Text to adopt XGMII

G. Zimmerman (CME Consulting/various), M. Tazebay (Broadcom)

1/24/2025

Figure 46–2—Reconciliation Sublayer (RS) inputs and outputs

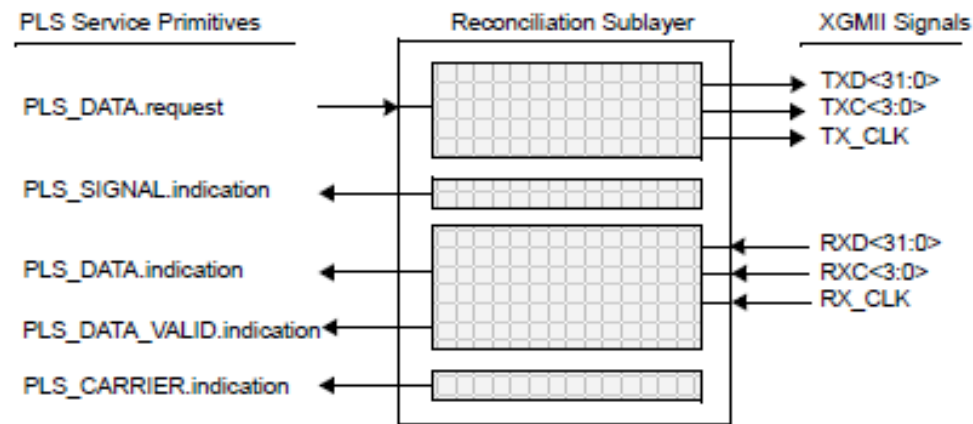
- XGMII has TX clock towards the PHY and RX clock from the PHY.
- The rates of these are specified by the MACs bit rate.

The XGMII is composed of independent transmit and receive paths. Each direction uses 32 data signals (TXD<31:0> and RXD<31:0>), four control signals (TXC<3:0> and RXC<3:0>), and a clock (TX_CLK and RX_CLK). Figure 46–2 depicts a schematic view of the RS inputs and outputs.
